PRODUCT CHANGE NOTIFICATION (PCN)

AMJE0909-0050-BKB-24
MODULAR CABLE

CHANGE NOTIFICATION: PCN 20220509_AMJE0909-0050-BKB-24

DESCRIPTION OF CHANGES:
CHANGE OF DATA SHEET
CHANGE OF DATA SHEET
New Draw.-No. ASS_7945_CArev02

AMJE0909-0050-BKB-24 OLD VERSION

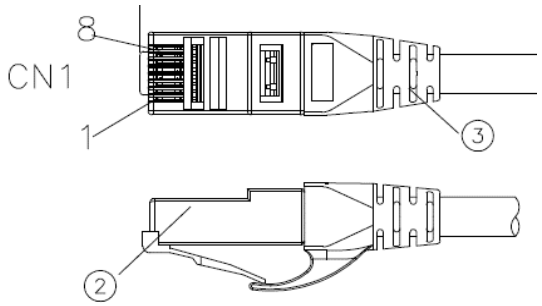
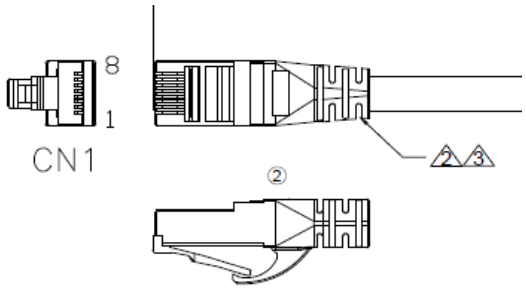
③	Molding	PVC 45P Color: see order code	NA	KG
②	CONNECTOR	RJ45 8P8C two fork Short type 3u" gold plated	2	PCS
①	CABLE	CAT6 UTP (24AWG*1PR)*4+PVC OD=5.8±0.3MM Color: see order code	NA	MM
NO:	NAME	DESCRIPTION	Q'TY	UNIT

3	Molding	PVC 65P Color: see order code ②	NA	KG
2	CONNECTOR	RJ45 8P8C PLUG 3u" gold plated ②	2	PCS
1	CABLE	CAT6 U/UTP (24AWG*1PR)*4+Cross+PVC Jacket OD=5.8± 0.3MM Color: see order code ②	NA	MM
NO:	NAME	DESCRIPTION	Q'TY	UNIT

Drawing-No.
ASS 7945 CA

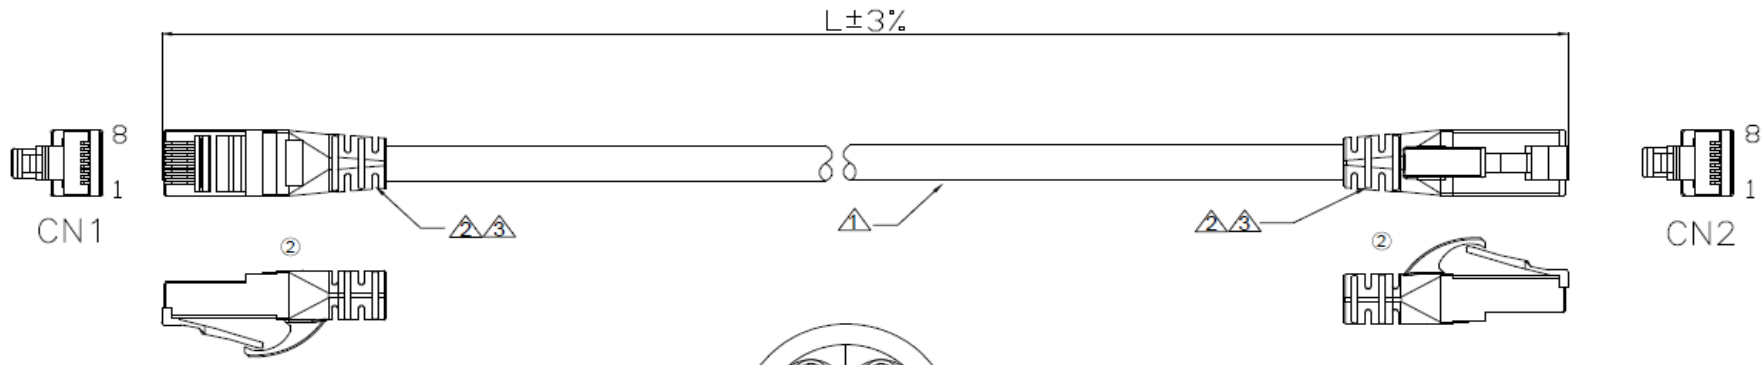
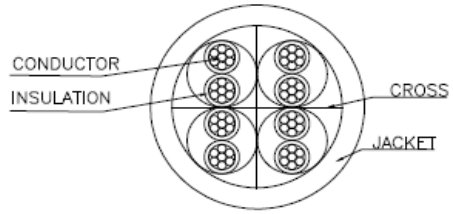
Id.	Modification	Date	Name
②	Change the plant	09.05.2022	Luca
①	Update the WSW order code	02.06.2017	Amy
⓪	Drawn	30.03.2017	Amy

NO:	NAME	DESCRIPTION	Q'TY	UNIT
3	Molding	PVC 65P Color: see order code ②	NA	KG
2	CONNECTOR	RJ45 8P8C PLUG 3u" gold plated ②	2	PCS
1	CABLE	CAT6 U/UTP (24AWG*1PR)*4+Cross+PVC Jacket OD=5.8± 0.3MM Color: see order code ②	NA	MM
